# Groundwater Transfer Review Summary Form

Transfer/PA # T- 14808

Application: T-14808

Applicant Name: Maley Road Hazelnuts, LLC

**Stream Depletion Analysis**

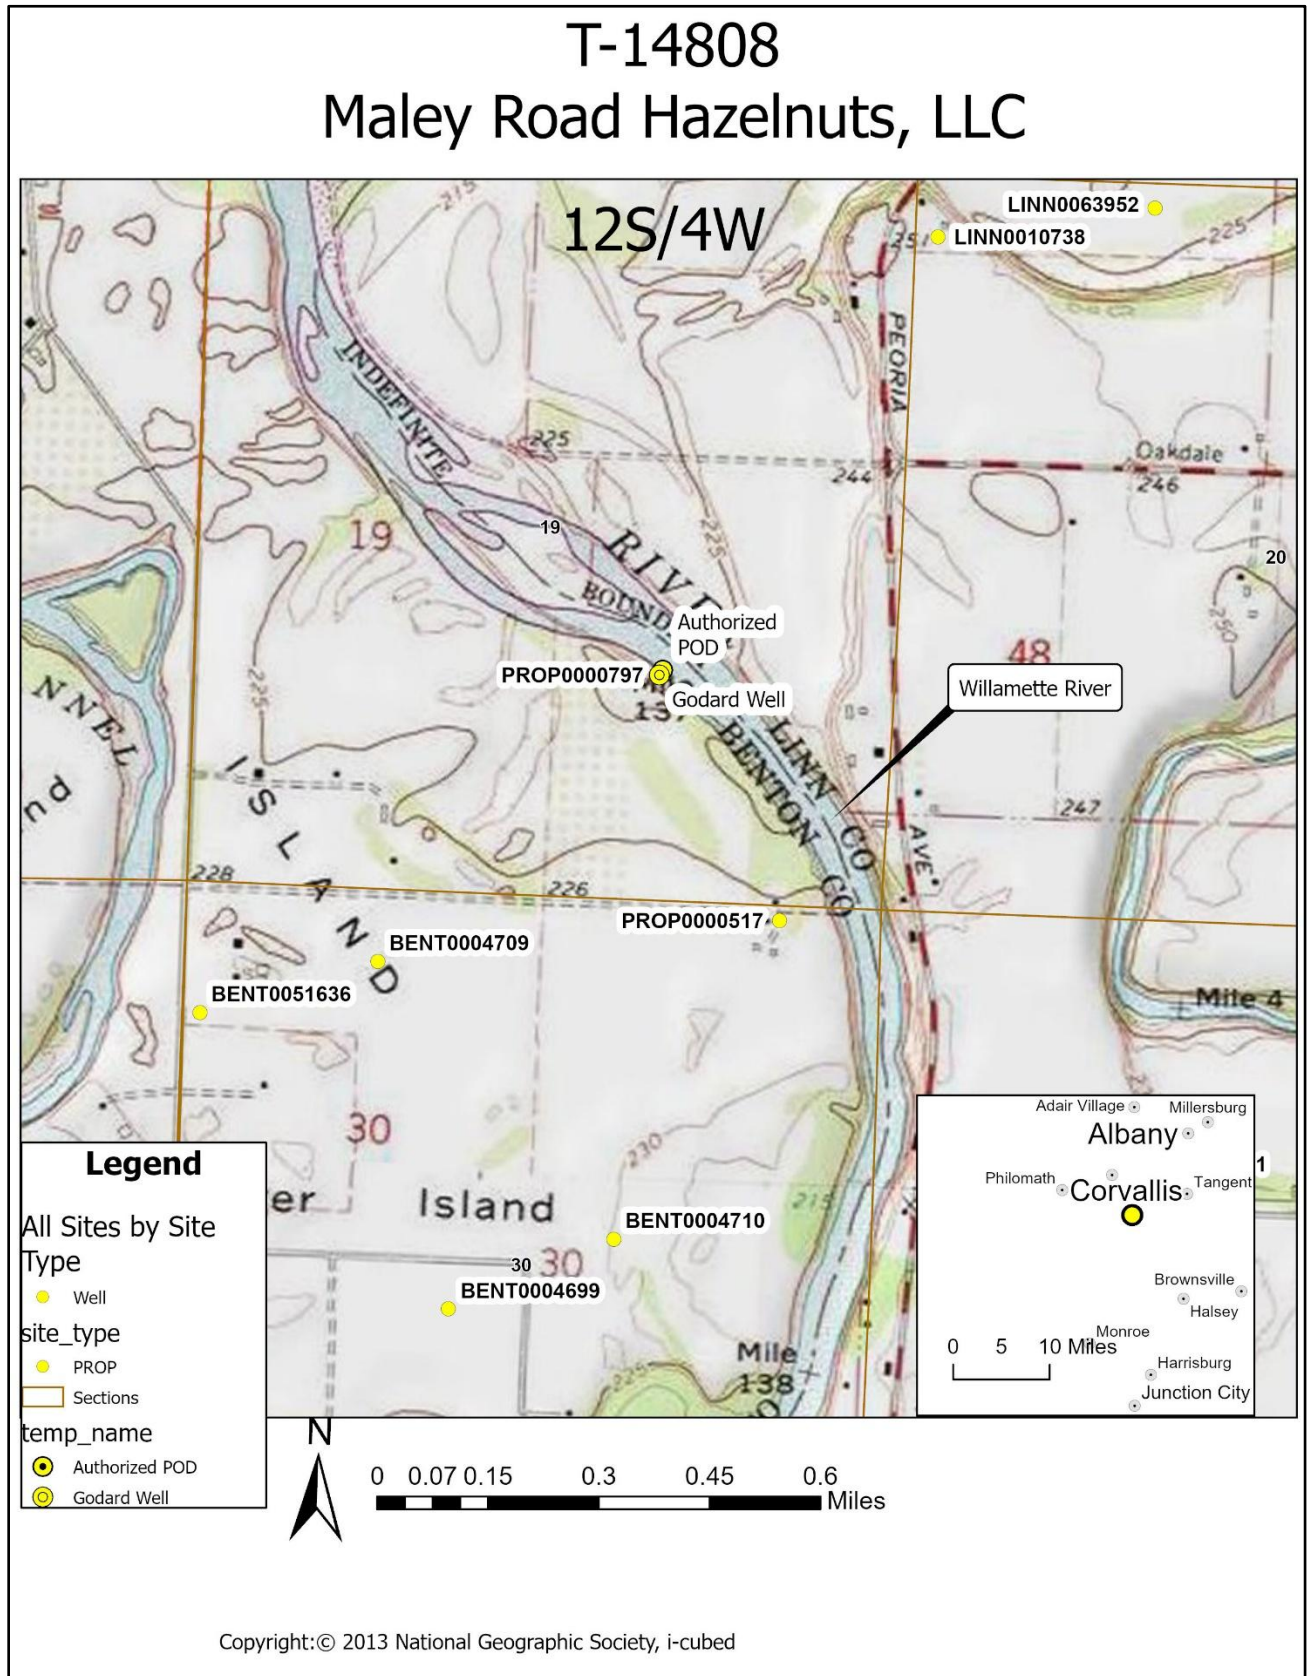
Yes  No Comments: The Hunt (1999) model was used to assess whether the proposed groundwater POA, Godard well (PROP 597) would meet the definition of “similarly” per OAR 690-380-2130 (see attached Stream Depletion Analysis); this definition requires that greater than 50 percent of the groundwater POA pumping rate be derived from stream depletion within 10 days of continuous pumping. The Hunt (1999) model was selected due to the apparent unconfined nature of the aquifer anticipated to be developed by the proposed POA. Parameters used in the Hunt (1999) model were derived from regional data and studies (Pumping Test Reports; Conlon et al., 201; Herrera et al., 2014) or are within a typical range of values for the given parameter within the hydrogeologic regime (Morris and Johnson, 1967; Heath, 1983). The nearby reach of the Willamette River is anticipated to be gaining (i.e., receiving groundwater discharge) based on numerical modeling by Herrera et al. (2014). The vertical conductivity value used in the Hunt (1999) model is the “Kv drain bed” parameter from Herrera et al., (2014).

Results of the analysis indicate that the proposed groundwater POA will likely derive greater than 50 percent of its pumping rate from stream depletion within 10 days of continuous pumping (see attached Stream Depletion Analysis). The proposed change in point of diversion will likely affect the Willamette River “similarly” (per OAR 690-380-2130) to the authorized points of diversion in Certificate 97291.
